SUBJECT: POINT BEACH NUCLEAR PLANT, UNITS 1 AND 2– STAFF
ASSESSMENT OF RESPONSE TO 10 CFR 50.54(f) INFORMATION
REQUEST – FLOOD-CAUSING MECHANISM REEVALUATION
(CAC NOS. MF6100 AND MF6101)

STAFF ASSESSMENT BY THE OFFICE OF NUCLEAR REACTOR REGULATION

RELATED TO FLOOD HAZARD REEVALUATION REPORT

POINT BEACH NUCLEAR PLANT, UNITS 1 AND 2

Figure 3.2-3. Location of Temporary Wave Barriers as Described for Scenario B

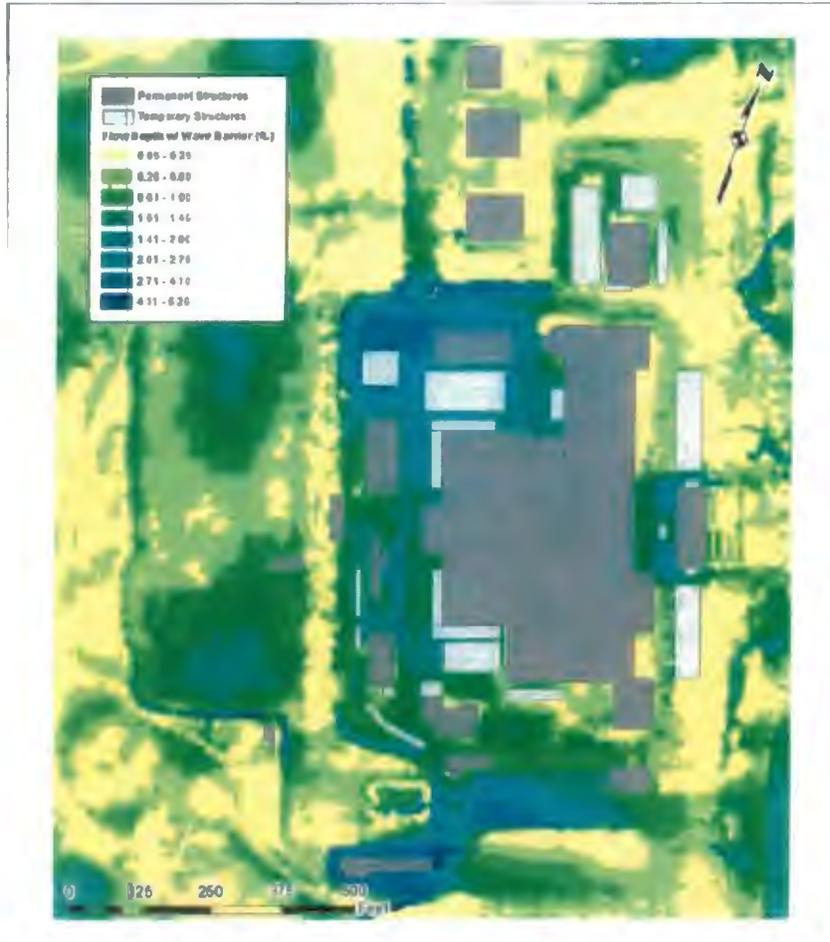
The licensee considered two scenarios for the LIP flooding analysis. Scenario A considers the temporary laydown areas completely occupied with equipment/containers. Scenario B is similar to Scenario A, but with additional temporary wave barriers installed adjacent to the CWPH. When the water level of Lake Michigan exceeds an administratively controlled limit, temporary wave barriers will be installed at the Point Beach site along the roll up doors on the north and south side of the CWPH, as shown on Figure 3.2-3 of this assessment. The licensee created Scenario B to assess the impact of these wave barriers, also referred to as door barriers. The plan for the installation of barriers was updated following a 2014 walkdown, and six barriers of 8 feet (ft) by 25 ft with a height of 3.5 ft were represented in the model as a wider structure of 15 ft by 25 ft (NextEra, 2015a).

In the FHRR, it is stated that during high lake level conditions, 3.5 ft high wave barriers are installed outside the CWPH rollup doors and sandbags are placed to seal the rollup doors. When the barriers are installed, the maximum LIP flood heights near the CWPH doors are projected to increase to 3.4 ft. The licensee stated during the audit (NRC, 2016) that the 100-year high lake level of 1.8 ft-Plant Datum for Lake Michigan was not used in the FLO-2D runoff model since site grade and associated features are at least 3 ft higher than the high lake level.
